**ADDENDUM 1**

Marathon County Public Library  
Restroom Renovation  
300 North 1<sup>st</sup> Street  
Wausau WI 54403

Commission No.: O25037  
Addendum Date: August 7, 2025

FIRST FLOOR RESTROOM PLANS

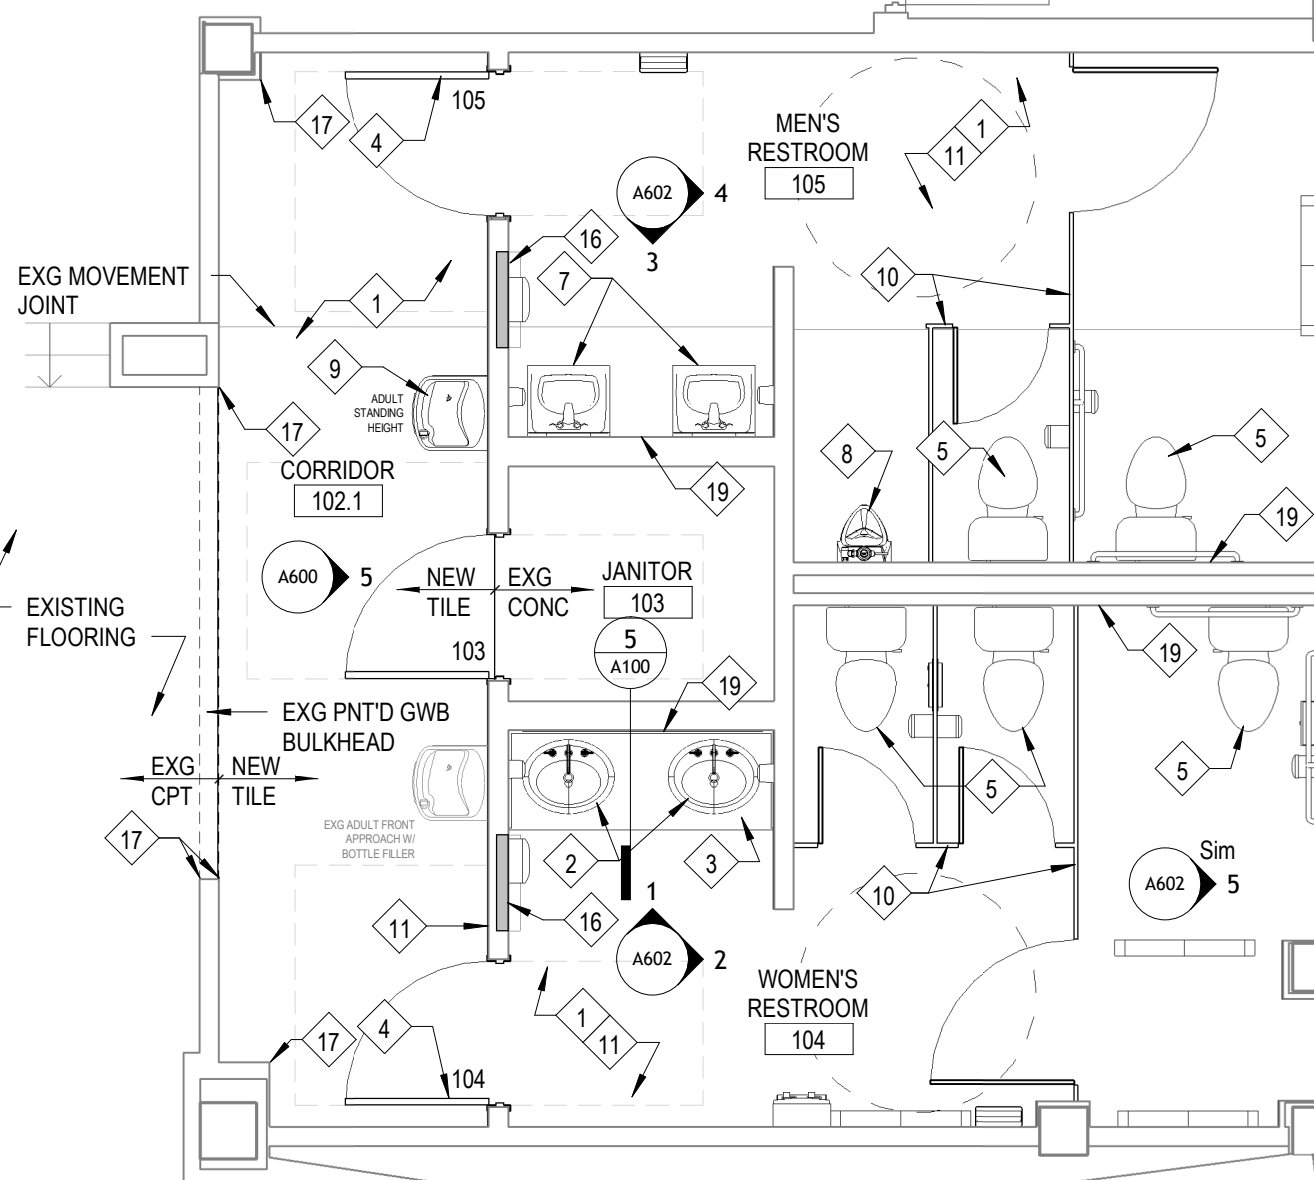
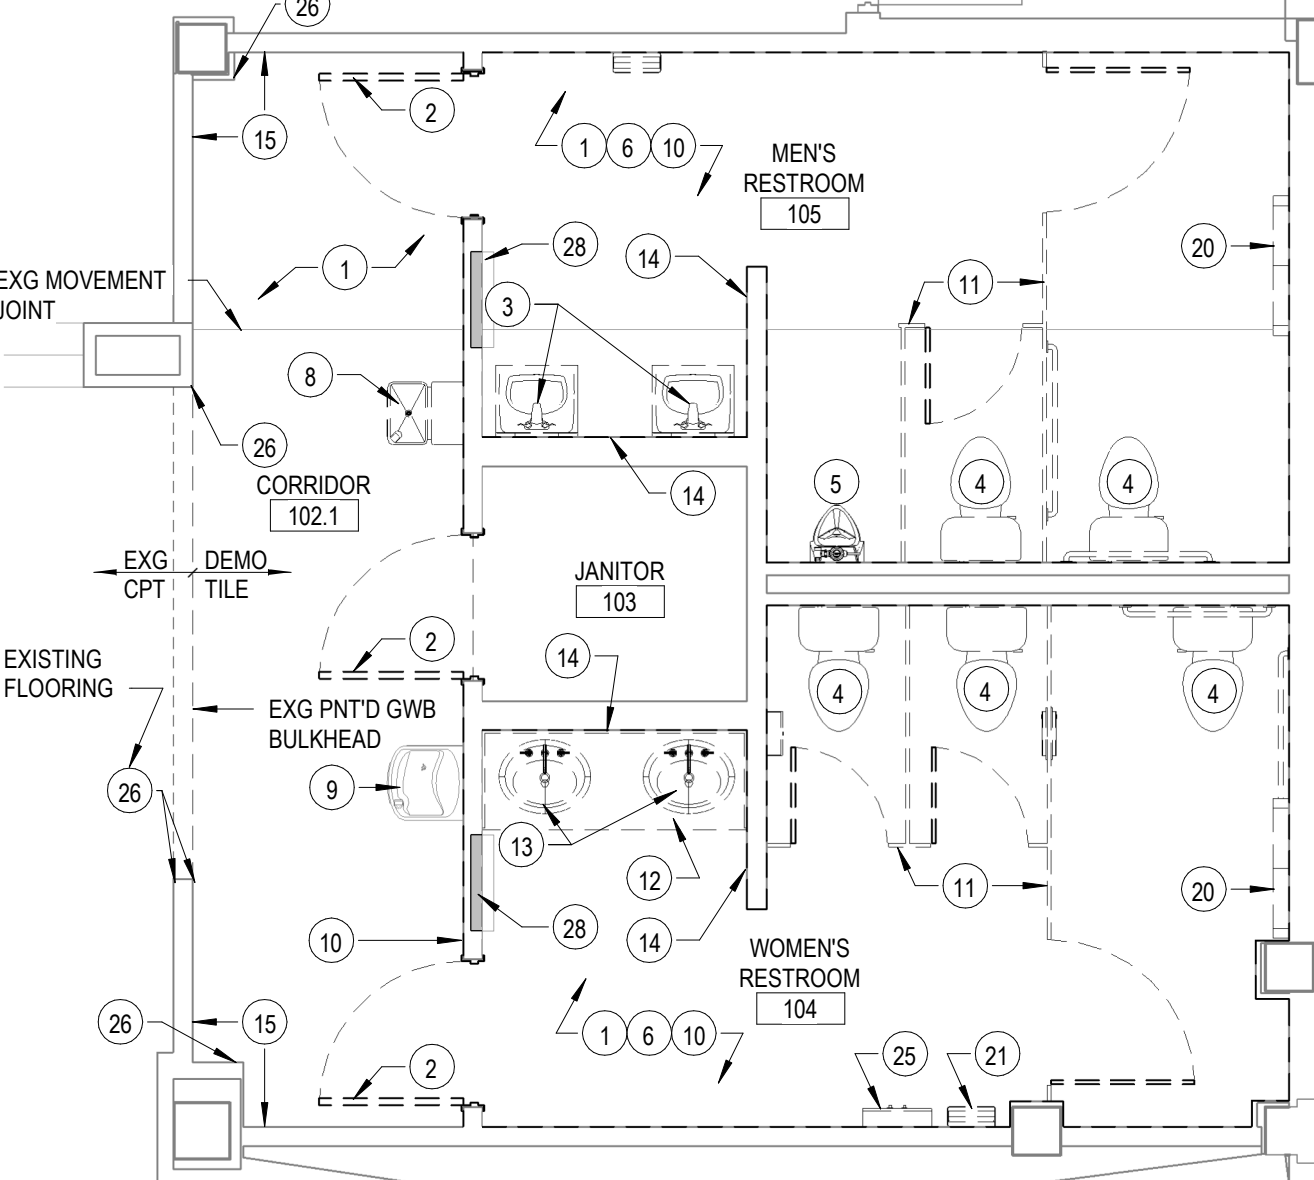
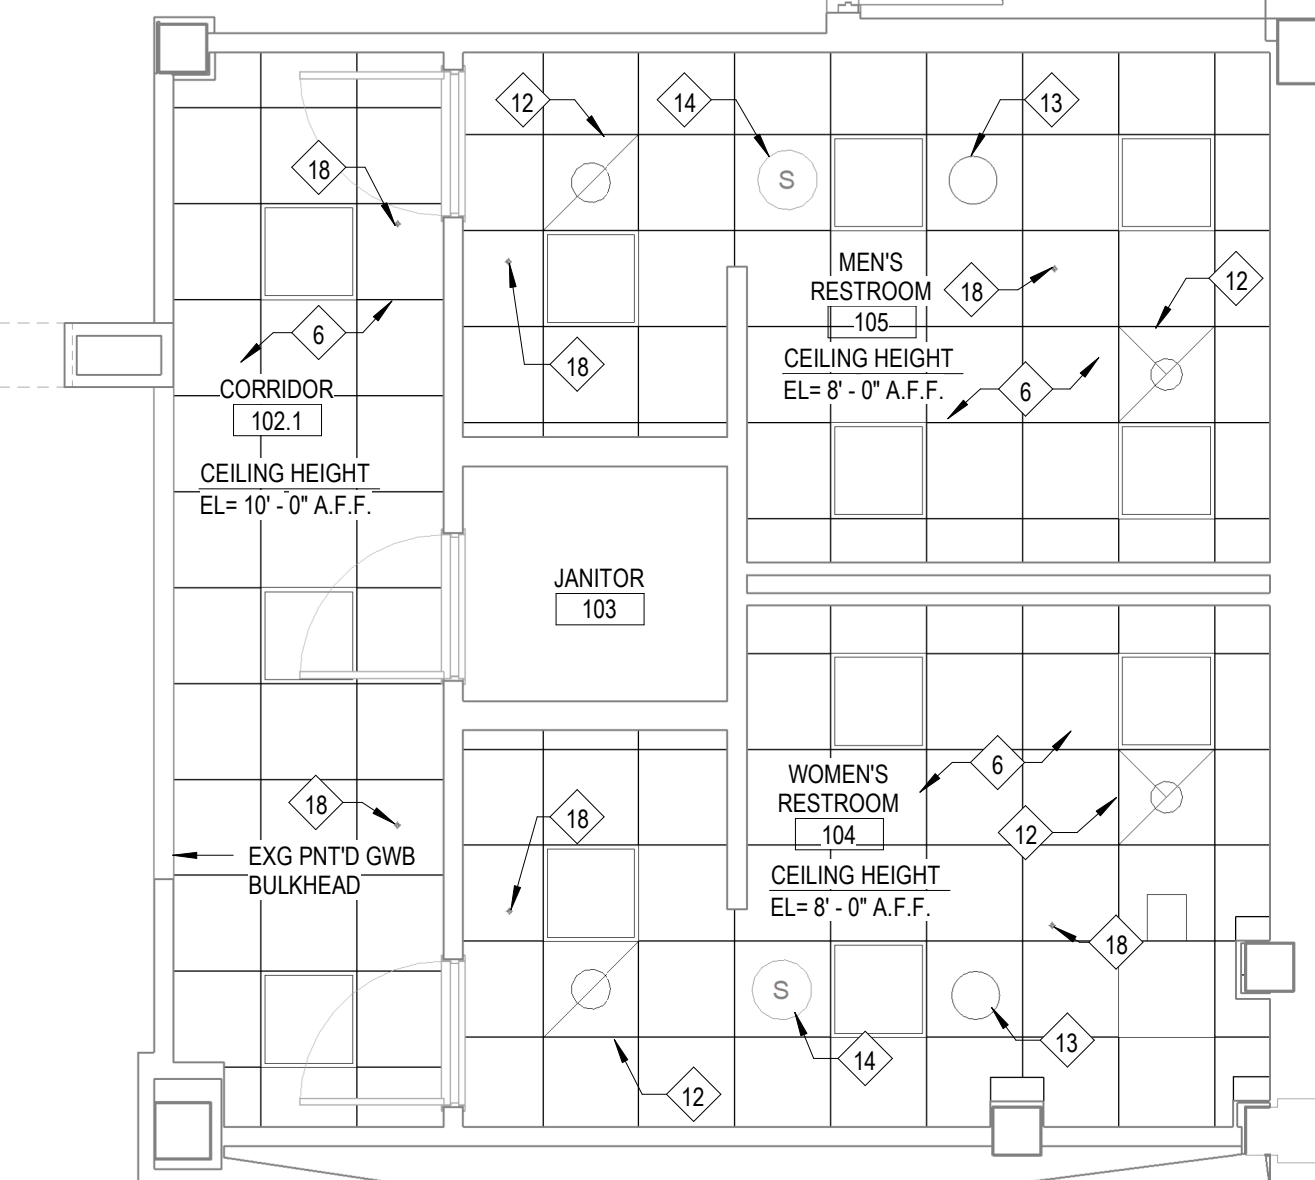
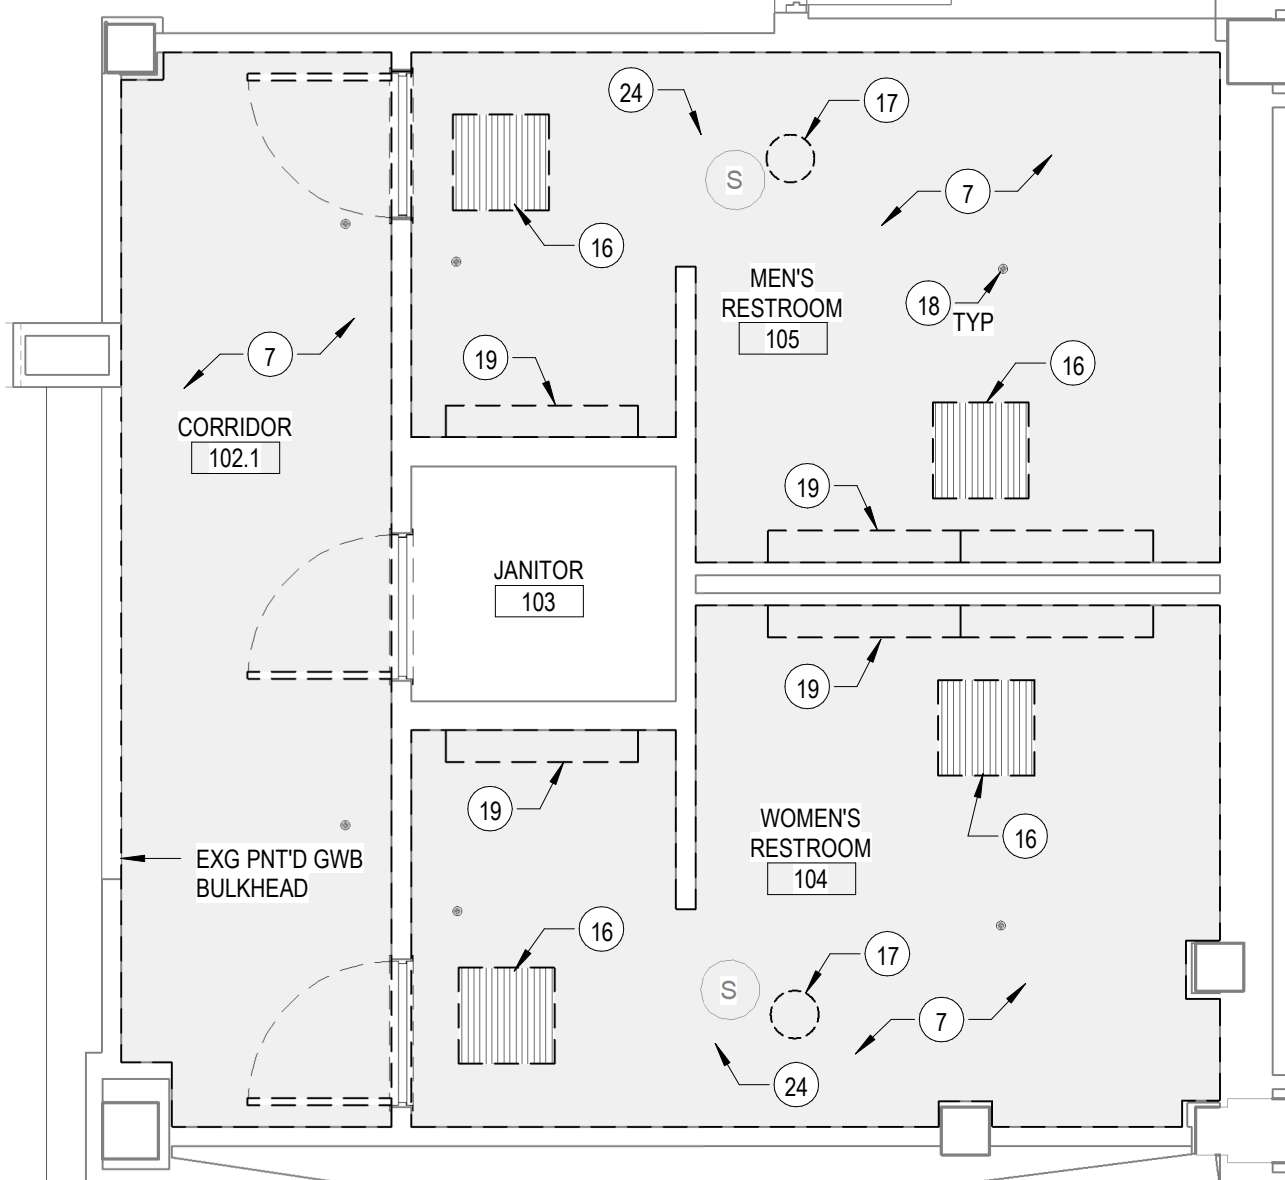
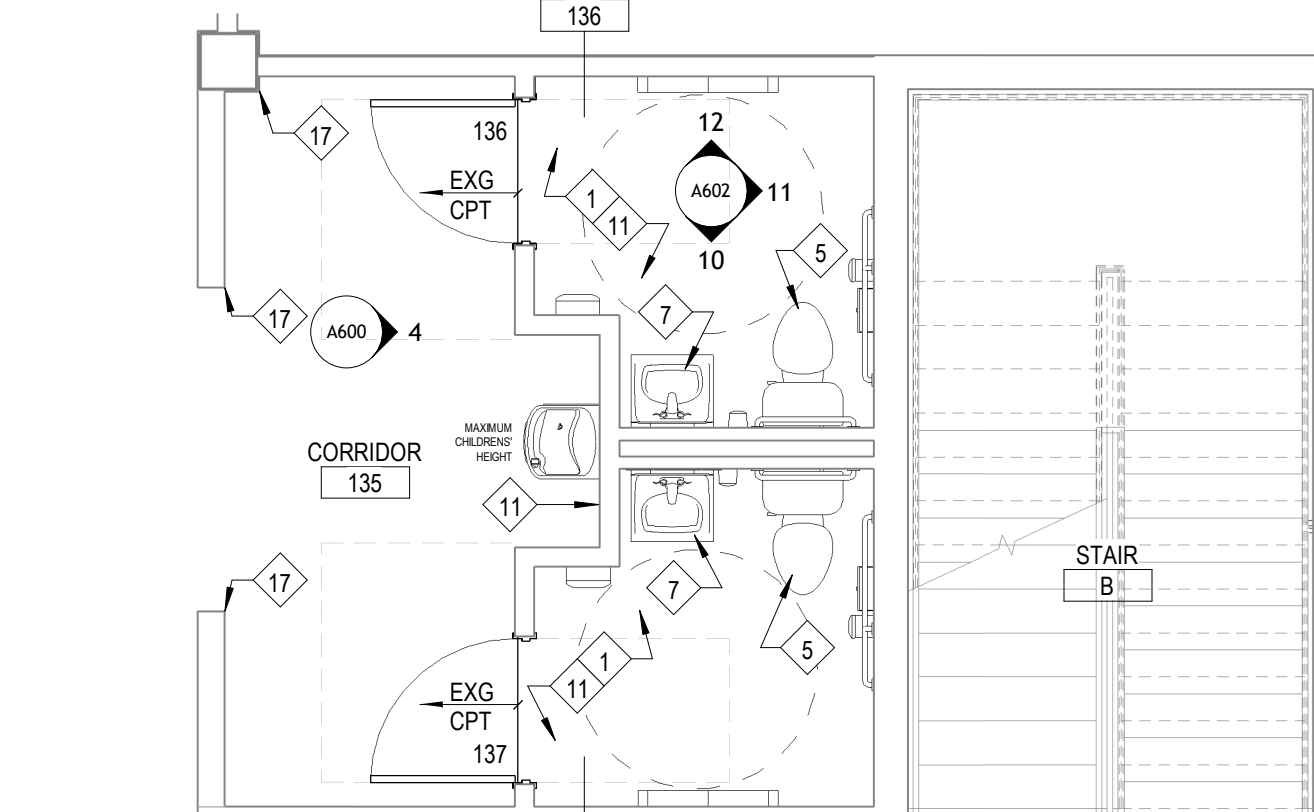
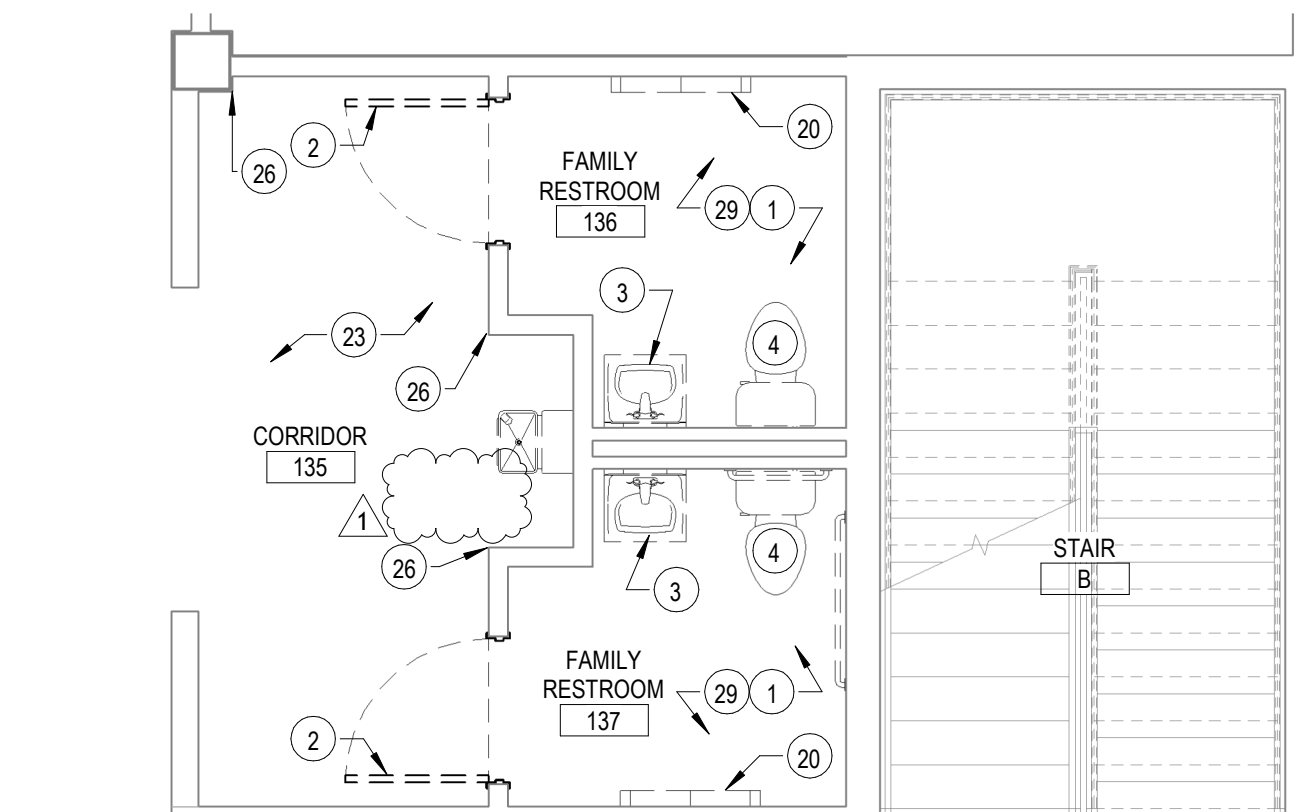
- 2) A101 First Floor Restroom Plans
  - a) 2/A101 First Floor Restroom Demo Plan: REMOVE demolition note 8 at Corridor 135.
  - b) Demolition Note 3: REVISE to state the following: “Remove existing lavatories and faucets; prepare existing HW, CW, and SAN pipes to accommodate installation of new. Provide temporary seal for sanitary pipes for duration of construction.”

- c) Demolition Note 13: REVISE to state the following: “Remove existing drop-in sinks and faucets; prepare existing HW, CW, and SAN pipes to accommodate installation of new. Provide temporary seal for sanitary pipes for duration of construction.”

- d) Work Description Note 2: REVISE to state the following: “Provide new American Standard ‘Aqualyn’ model 0475.047 drop-in sink with new Sloan ‘Optima’ model EAF-350-BAT-ISM-CP-0.5GPM-AER-IQ-FCT faucet. Provide new grid strainer drain, P-trap, and trap arm. Extend/rework existing CW, HW, and SAN pipes as required for connection.”

- e) Work Description Note 7: REVISE to state the following: “Provide new American Standard ‘Lucerne’ model 0356.421 wall-hung lavatory with new Sloan ‘Optima’ model EAF-350-BAT-ISM-CP-0.5GPM-AER-IQ-FCT faucet. Provide new grid strainer drain, P-trap, and trap arm. Extend/rework existing CW, HW, and SAN pipes as required for connection. If existing fixture carrier or wall hanger is not suitable for re-use, notify the Architect.”
